DIVISION OF RECLAMATION, MINING AND SAFETY

**RE: Response to Continuation of Complaint,
Battle Mountain Resources, Inc., San Luis Project, Permit No. M-1988-112**

MINE NAME: San Luis Project	MINE/PROSPECTING ID#: M-1988-112	MINERAL: Gold and silver	COUNTY: Costilla
INSPECTION TYPE: Multi Person Inspection	INSPECTOR(S): TonyWaldron, RussMeans, WallyErickson	INSP. DATE: March 18, 2013	INSP. TIME: 10:00
OPERATOR: Battle Mountain Resources, Inc.	OPERATOR REPRESENTATIVE: Lawrence Fiske, Julio Madrid, Steve Carino, and Jim Witwer	TYPE OF OPERATION: 112d-3 - Designated Mining Operation

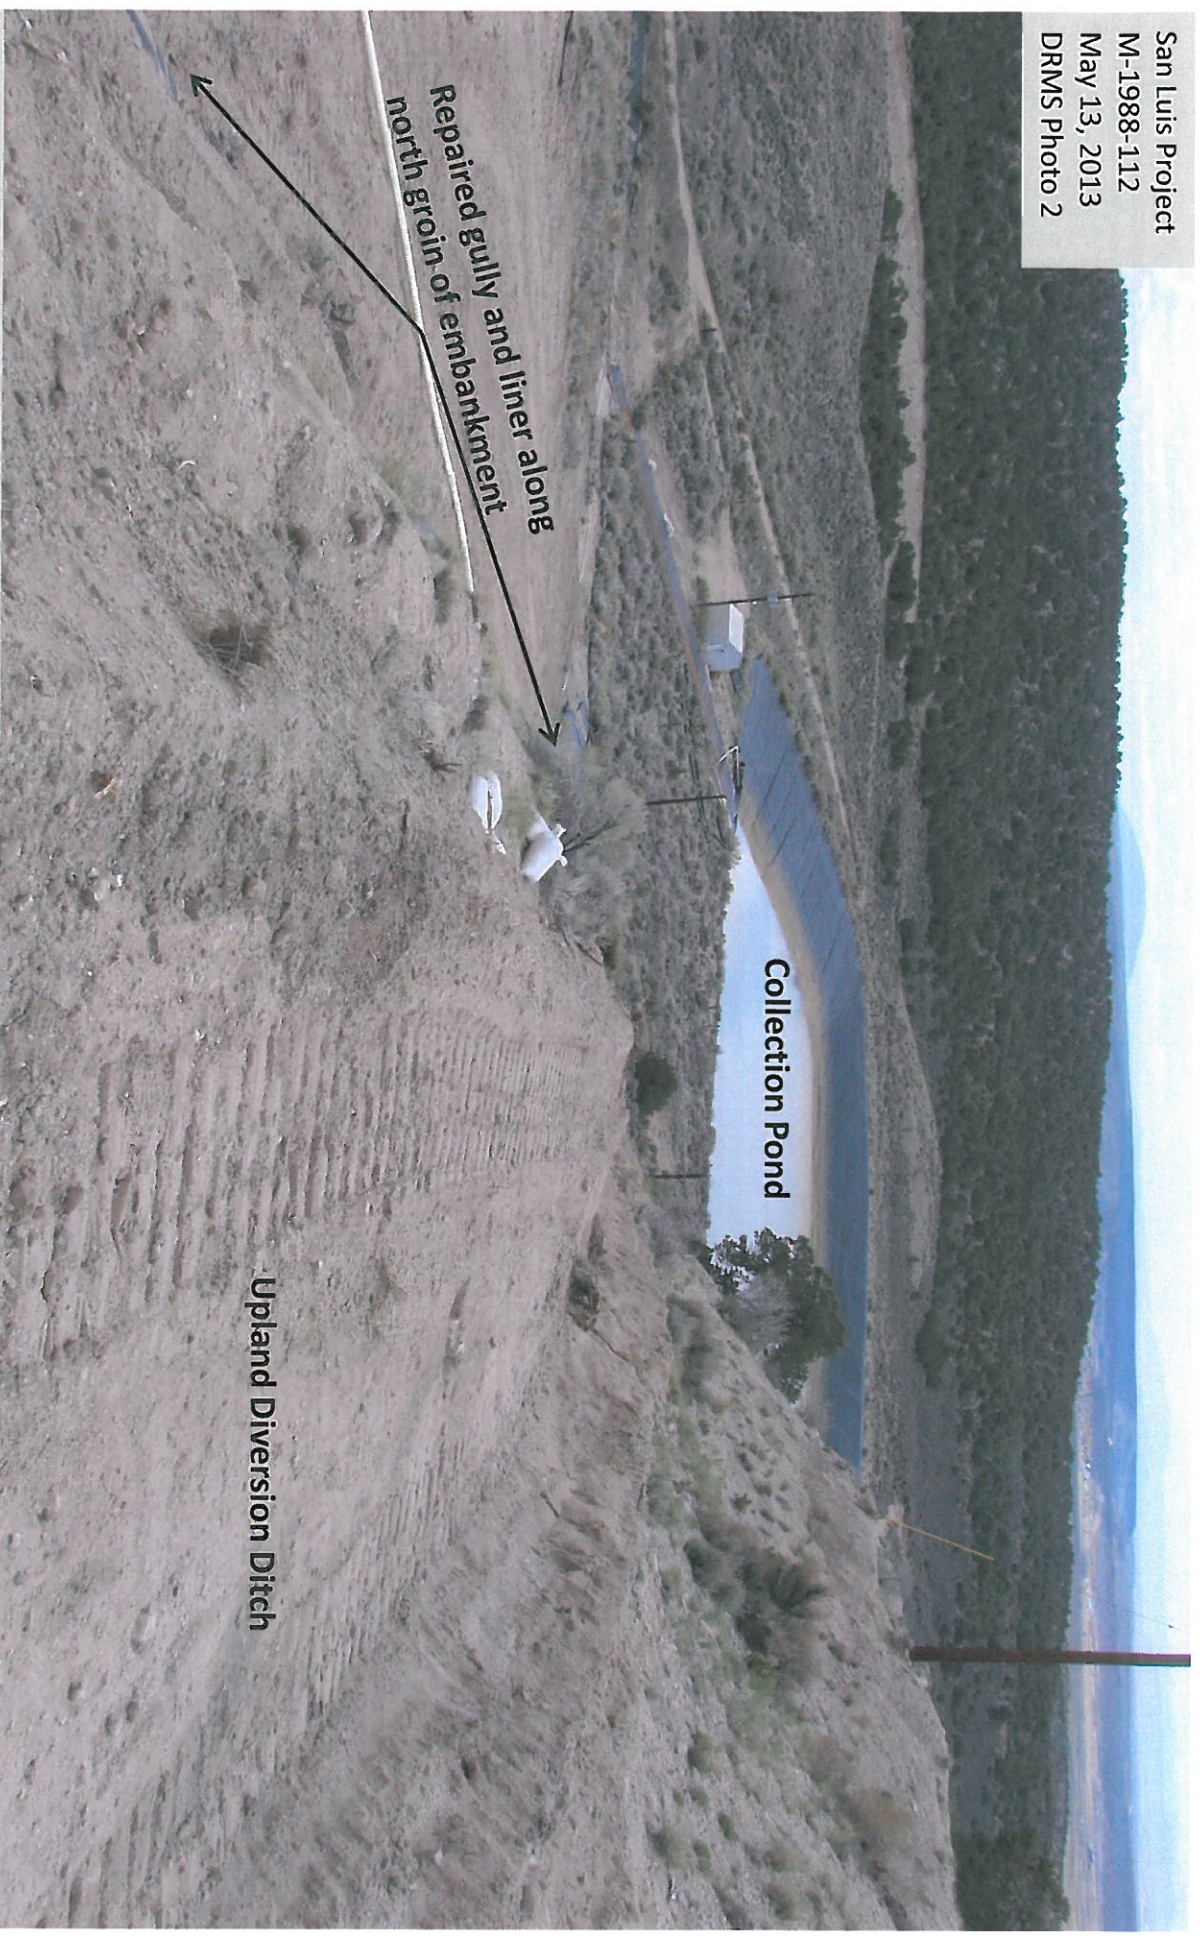
As shown in DRMS Photo 1, the upstream slope of the main embankment of the tailing pond was well vegetated and appeared stable; evidence of slumping, settling or excessive erosion was not observed. The surface area of the tailings is approximately 192 acres, which includes an approximate 20-acre area for the free water pool. The Operator identified markers at approximately 200 feet upstream from the embankment, which delineate the setback distance for the free water pool from the embankment. During the time of this inspection the free water pool was visually estimated at greater than 500 feet distance from the main embankment. The Operator indicated the current depth of the free water pool to be approximately 2 feet. The free water pool contains drainage from precipitation, fluids pumped from the collection pond, and brine and untreated West Pit water pumped from the water treatment plant.

View north, taken from the south side of the tailing pond, showing the upstream slope of the main embankment, portions of the 192 acre tailing pond, and the free water pool.

As shown in DRMS Photo 2, the Operator has recently completed routine maintenance and repair of minor erosion features on the downstream slope of the main embankment of the tailing pond. The area shown in photo 2 is located at the north end of the embankment, at the transition of the earthen embankment with the geosynthetic liner covering the native slope. The repairs included surface grading and reseeding, installation of new liner material to replace eroded liner, and excavation of a diversion ditch to intercept upland drainage

and thereby minimize potential for future erosion to the embankment. The recently disturbed area was visually estimated at 200 feet long by 50 feet wide, or approximately 0.23 acres. The downstream slope of the embankment was not steeper than 3H:1V, as indicated in the approved plans and as-built certifications for the embankment. The downstream slope of the embankment appeared well vegetated and stable; evidence of slumping, settling or excessive erosion was not observed.

View west, taken nearby the crest and north end of the main embankment of the tailings pond, showing portions of the downstream slope of the embankment and the collection pond of the tailings repository. The Operator had recently conducted routine maintenance to control erosion. Erosion control methods employed by the Operator included surface grading along the transition of the earthen embankment with the liner, replacement of eroded sections of the liner, and installed a diversion ditch to intercept upland drainage and minimize potential for future erosion to the embankment.

The referenced disturbance was associated with the replacement of a portion of the stormwater conveyance liner on the north, downgradient side of the embankment as described in the response to paragraph 5 above. That repair work was completed in April 2013. Final reseeded will be completed in spring 2014.

San Luis Project
M-1988-112
May 13, 2013
DRMS Photo 3

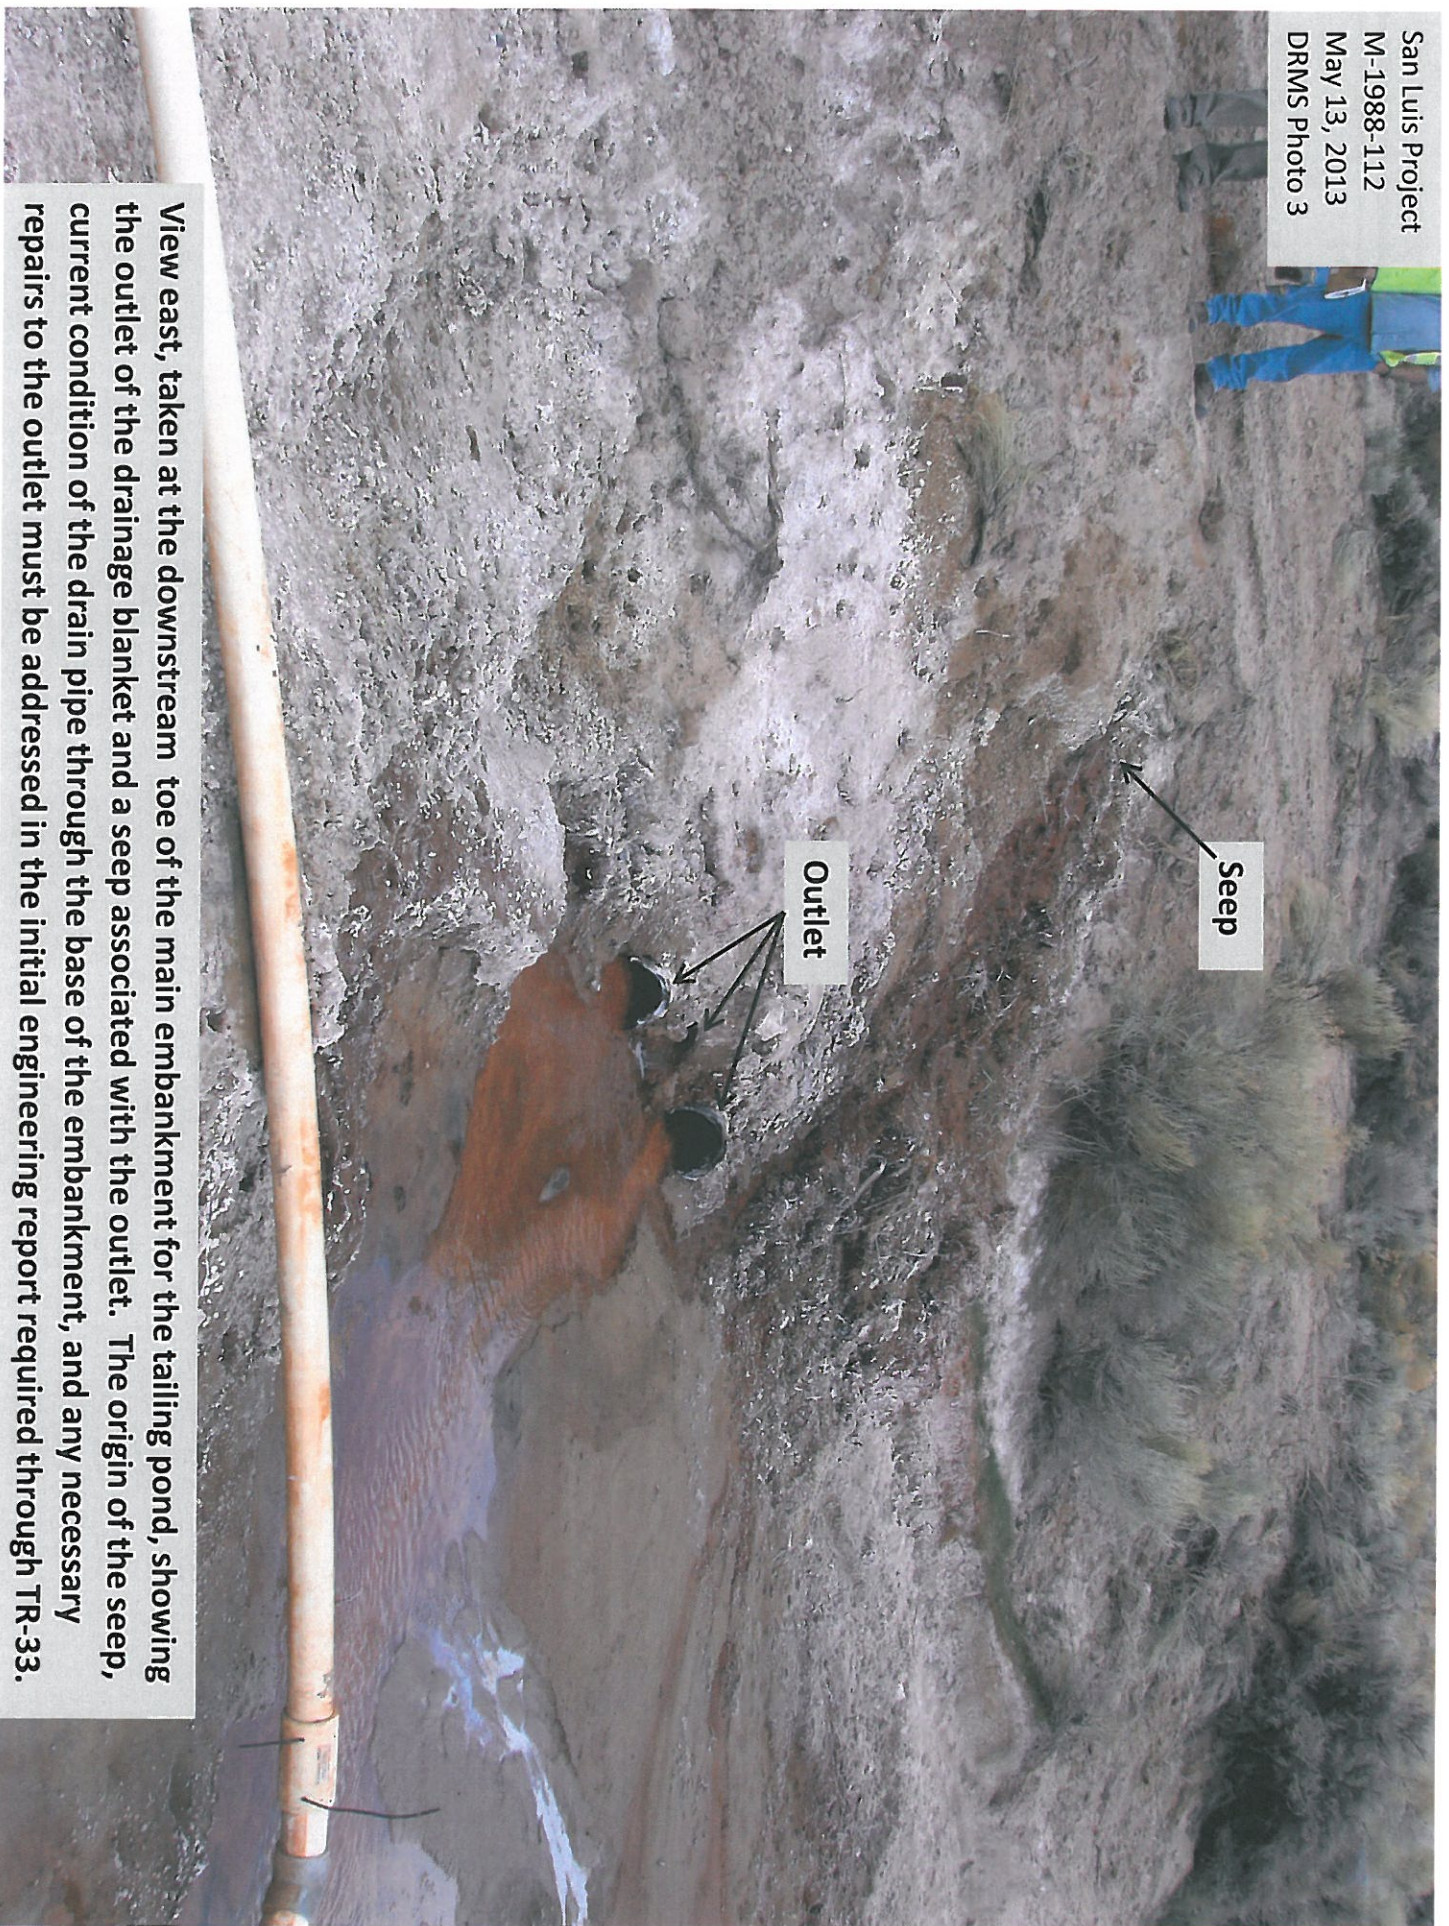
View east, taken at the downstream toe of the main embankment for the tailing pond, showing the outlet of the drainage blanket and a seep associated with the outlet. The origin of the seep, current condition of the drain pipe through the base of the embankment, and any necessary repairs to the outlet must be addressed in the initial engineering report required through TR-33.

Detail photo of the drainage blanket outlet, shown in photo 3. Discharge from the outlet is contained at the collection pond and recycled to the free water pool for disposal by evaporation. Flow rate was estimated at 30 gpm. Routine maintenance to the outlet, to include sediment removal from the culverts and stabilization of the slope immediately above the culverts, appears necessary to ensure the outlet continues to function in accordance with approved designs.

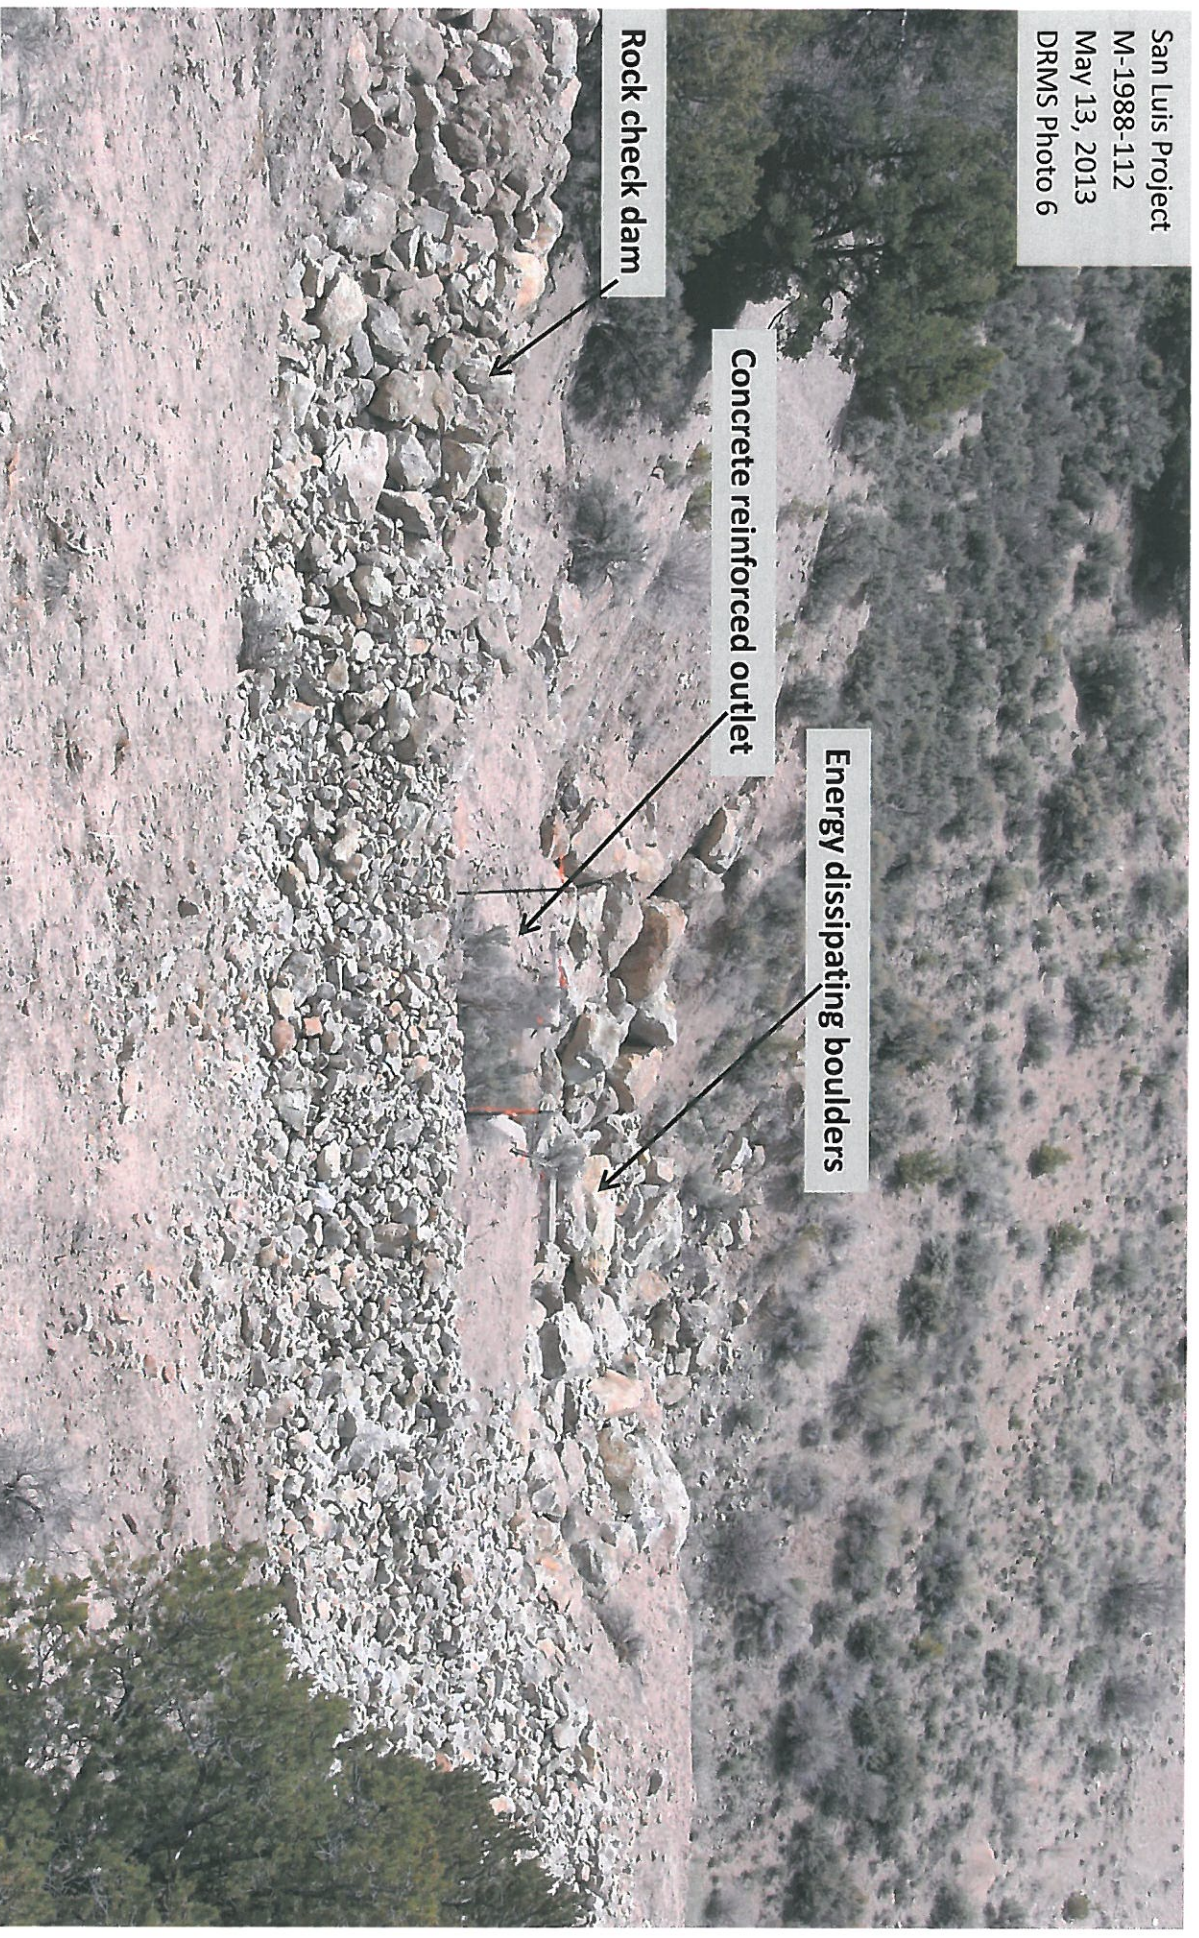
View west, showing portions of the upland diversion ditch for the south side of the tailings repository, and the inlet of its associated drop structure located at the crest of the embankment. The south upland diversion structure is designed to safely convey flows up to and including the 100 year, 24 hour storm event. Permit documents define the 100 year, 24 hour storm event at 2.9 inches precipitation and calculate storm runoff from the south drainage area at 292 cfs. As shown in this photo, the inlet of the drop structure did not include a debris screen.

View west, taken nearby the crest and south end of the main embankment of the tailing pond, showing the drop structure outlet for the south diversion ditch. The Operator had recently conducted routine maintenance to control erosion. Erosion control methods employed by the Operator included surface grading, placement of riprap armoring, installation of rock check dam, and placement of energy dissipating boulders at the drop structure outlet. The outlet of the south diversion ditch appeared well maintained and stable; evidence of excessive erosion was not observed.

Photo 9 – Seepage drain outfall at the downstream toe (3x12' HDPE pipes). There is reportedly a large seepage collection pipe under the dam. NOTE: Uncontrolled seepage exiting higher on the slope above the drain outfalls (red arrow).

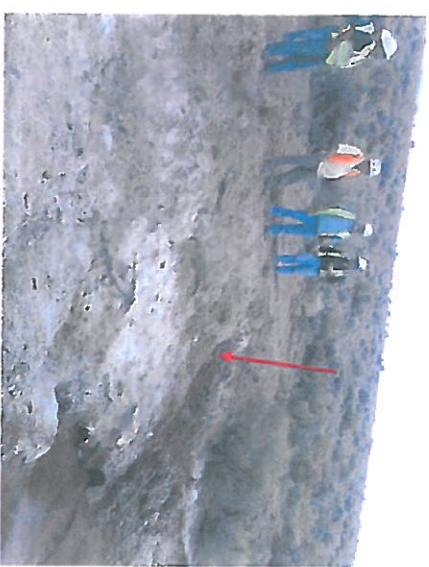
Photo 8 – Seepage at toe of the main dam. Majority of seepage comes through collection drain, but some seepage appears to be uncontrolled (see Photo 9).
